GE Hitachi Nuclear Energy

MFN 08-145

**Subject: Response to NRC Request for Additional Information Letter 131
Related to the ESBWR Design Certification – Radioactive Waste
Management Systems – RAI Numbers 11.2-16S01, 11.2-17
through 11.2-31, 11.3-4 through 11.3-12, 11.4-15S02, 11.4-19
through 11.4-32, and 11.5-48 through 11.5-53**

**Response to Portion of NRC Request for
Additional Information Letter No. 131**

Figure 11.4-3. ~~SWMS Solid Radwaste Dewatering System (Conceptual Design)~~ Wet Solid Waste Processing Subsystem

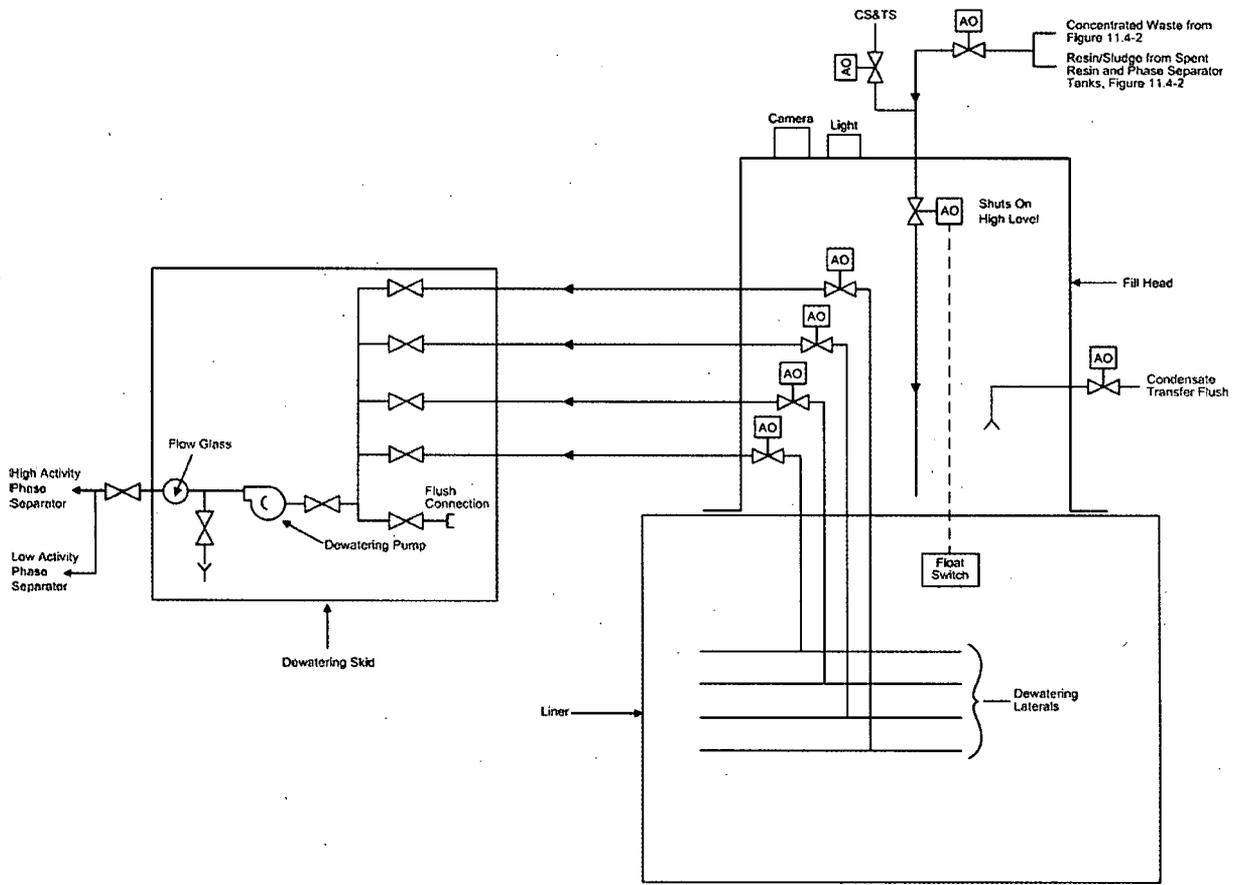
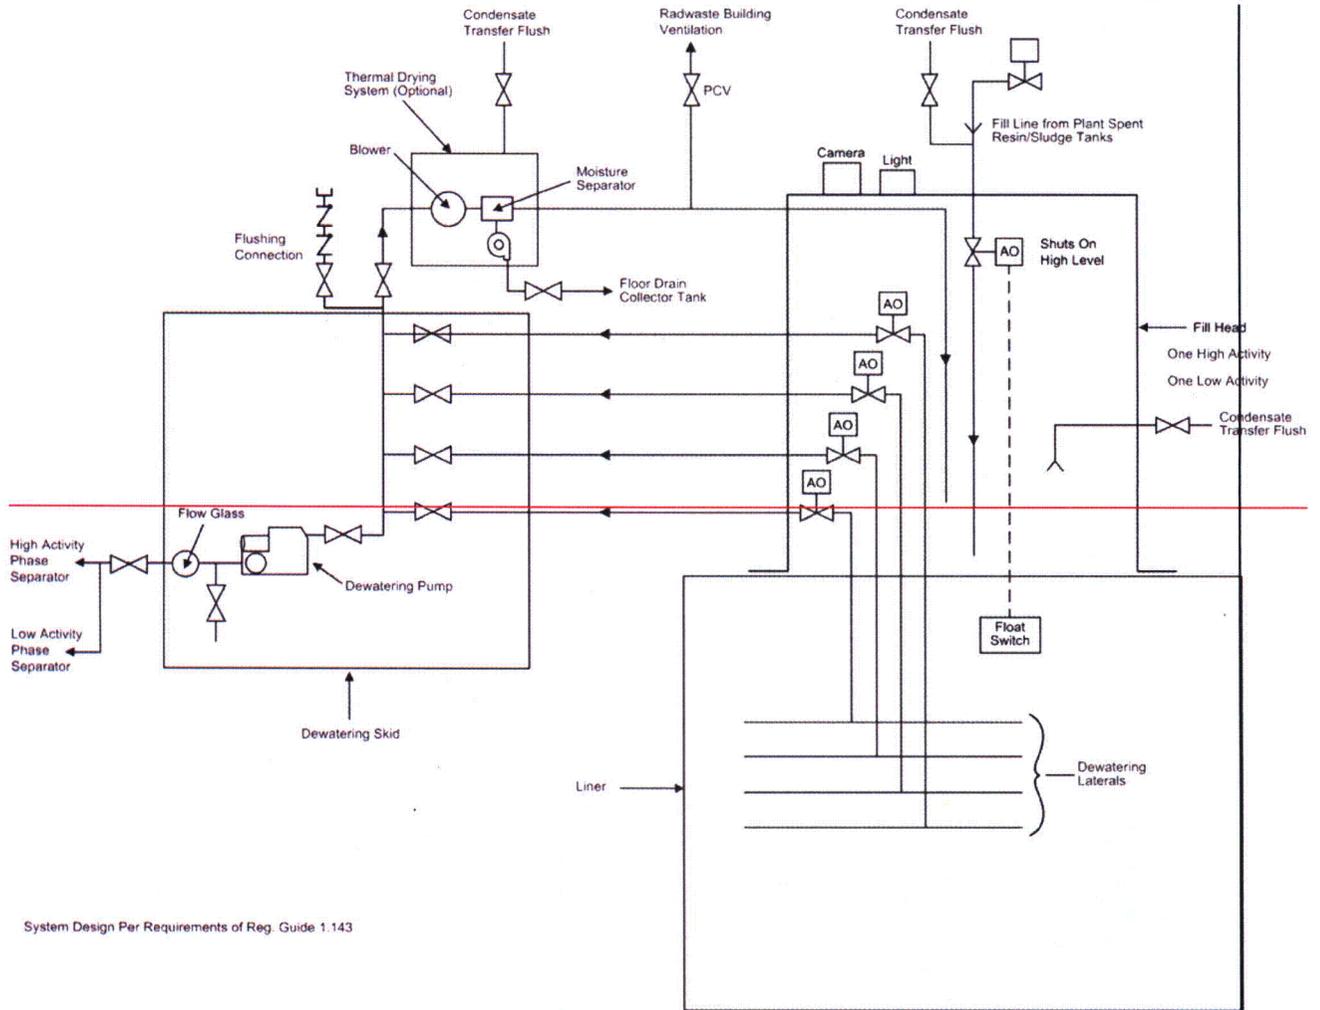
The "Thermal Drying Unit" as described in DCD, Tier 2, Section 11.4.2.2 "wet solid waste processing subsystem" and shown on Figure 11.4-3, is listed as an option. Clarify if this equipment is within the scope of the DCD, Tier 2 and revise DCD, Tier 2, Section 11.4.2.2 accordingly.

DCD, Tier 2, Figure 11.4-3 describes the function of the "dewatering pump. This pump appears to be drawn backwards in the figure. As drawn, it appears to be pumping from the High and Low Activity Phase Separators into the Liner and Thermal Drying Units. Also, on the dewatering skid drawing, there is an open gate valve with no disposition or connection to other portions of the subsystem. Confirm the flow direction of the dewatering pump, address the inconsistencies in system flow paths, and revise DCD, Tier 2, Section 11.4.2 and Figure 11.4-3 accordingly.

GEH concurs the need to clarify DCD, Tier 2, Subsection 11.4.2.2 "wet solid waste processing subsystem" and Figure 11.4-3, and will remove the "Thermal Drying Unit".

GEH agrees with the inconsistencies in flow direction of the dewatering pump, system flow paths, and will revise DCD, Tier 2, Figure 11.4-3 accordingly.

Figure 11.4-4. Dry Active Waste Processing

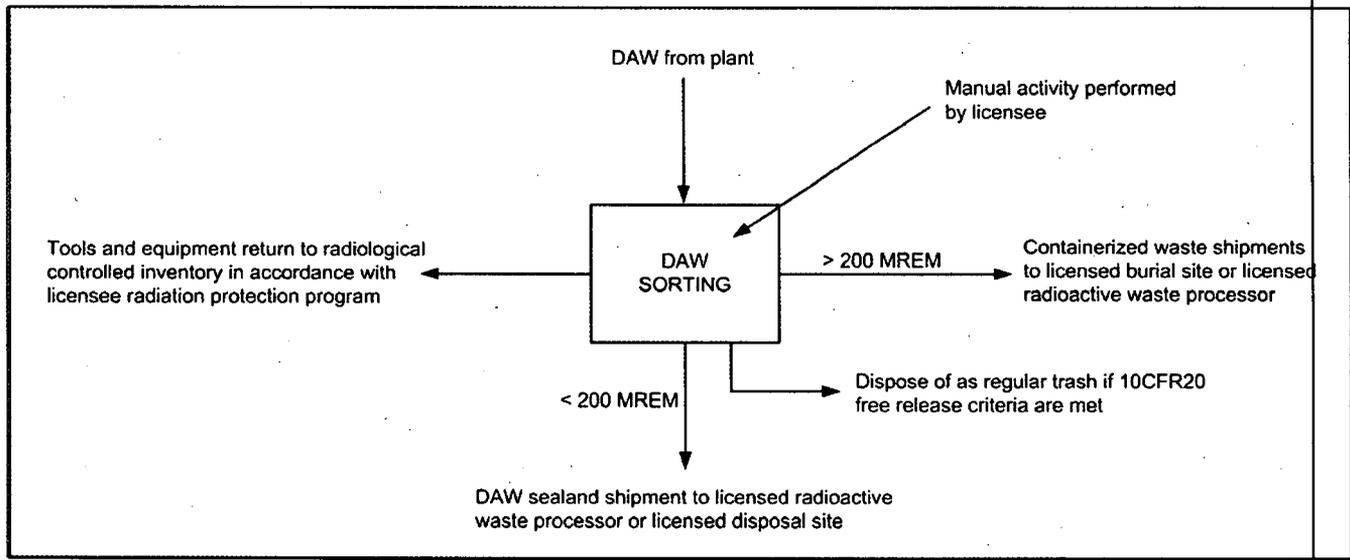
DCD, Tier 2, Figure 11.4-4 shows the disposition of dry solid wastes, but it does not address NRC requirements and policy for their disposition.

- a. For wastes processed manually, the figure should note that such activities are performed by the COL holder.*
- b. For tools and materials returned to plant, the figure should note that they would be returned for controlled use and uncontrolled use consistent with the COL holder's radiation protection program.*
- c. For disposal as regular trash, the figure should note that such dispositions would comply with the NRC policy on non-detectable activity for the release of materials and equipment from nuclear power plants.*
- d. For radioactive waste destined for DAW Sealand shipments, the figure should note that the endpoints of such shipments are authorized low-level radioactive waste disposal sites and licensed waste processors.*

As shown, the figure conveys disposition methods of radioactive materials contrary to Part 20.2001 and NRC policy for the release of materials and equipment from nuclear power plants in unrestricted areas. Accordingly, revise DCD, Tier 2, Figure 11.4.4 by changing the legend or introducing appropriate footnotes to each shown disposition endpoints.

GEH agrees with the staff's identification of inadequacy of the dry active waste (DAW) processing description in DCD, Tier 2, Figure 11.4.4, and will revise the figure to describe disposition methods of radioactive materials that are not contrary to Part 20.2001 and NRC policy for the release of materials and equipment from nuclear power plants in unrestricted areas.

DCD, Tier 2, Figure 11.4.4 will be revised as noted on the attached markup.
